Item 6.**Development Application: 84 City Road, Chippendale - D/2019/823**

File No.: D/2019/823

Proposal Summary: The application seeks consent for alterations and additions to the existing 10 room boarding house at No.84 City Road, Chippendale. The works consist of tree removal, excavation, partial demolition of the rear of the building, internal alterations, rear ground floor extension, rear facing dormer window and a new rear lane structure. The proposal will result in no additional rooms and will accommodate a maximum of 11 people. The application is being assessed concurrently with an identical proposal for the neighbouring property at No.82 City Road (D/2019/822), which is under the same ownership as the subject site.

Figure 10: Section

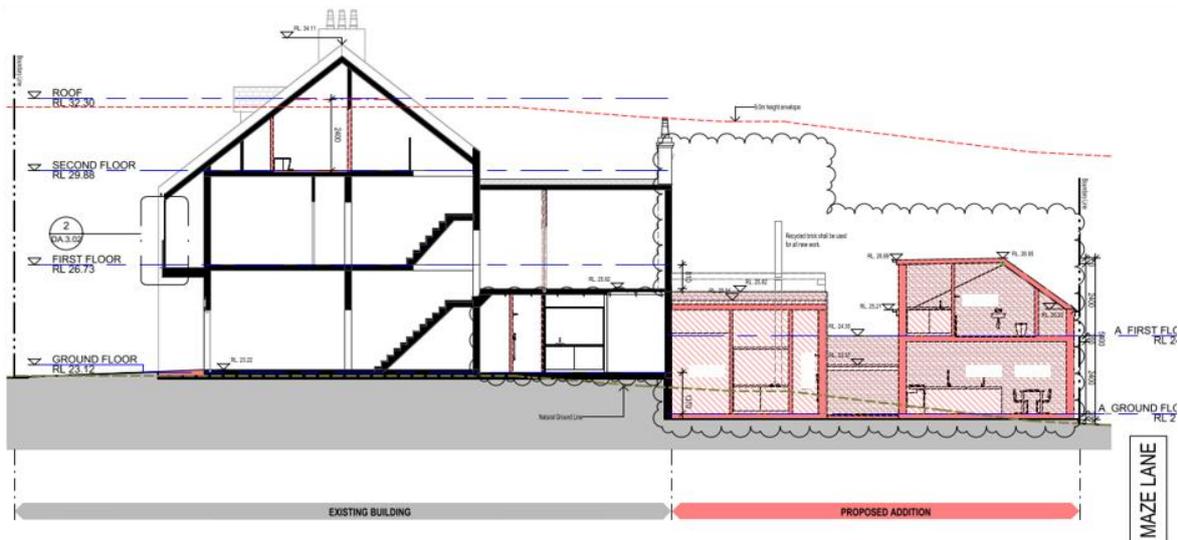
34. The site is subject to a maximum height control of 9m. The proposed development involves the addition of a new rear facing dormer window at a height of 10.48m. The existing building has a height of 11m to the ridge line.
35. A written request has been submitted to Council in accordance with Clause 4.6(3)(a) and (b) of the Sydney LEP 2012 seeking to justify the contravention of the development standard by demonstrating:
- (a) That compliance with the development standard is unreasonable or unnecessary in the circumstances of the case; and
 - (b) That there are sufficient environmental planning grounds to justify contravening the standard.
36. A copy of the applicant's written request is provided at Attachment D.

The height breach in this case is caused by a replacement dormer window at the rear of a terrace building that forms part of a contributory group of buildings. A dormer window is anticipated on terraces with high vaulted ceilings and/or attics and in this case has been designed to meet the criteria in the Council's DCP, having a set down from the principal ridge of the roof of 200mm and set in from the edges of the building by 975mm so that it extends 4 metres across the roof plane.

46. For the reasons provided above the requested variation to the height of buildings development standard is supported as the applicant's written request has adequately addressed the matters required to be addressed by cl 4.6 of the Sydney Local Environmental Plan 2012 and the proposed development would be in the public interest because it is consistent with the objectives of Clause 4.3 Height of Buildings and the R1 - General Residential zone.
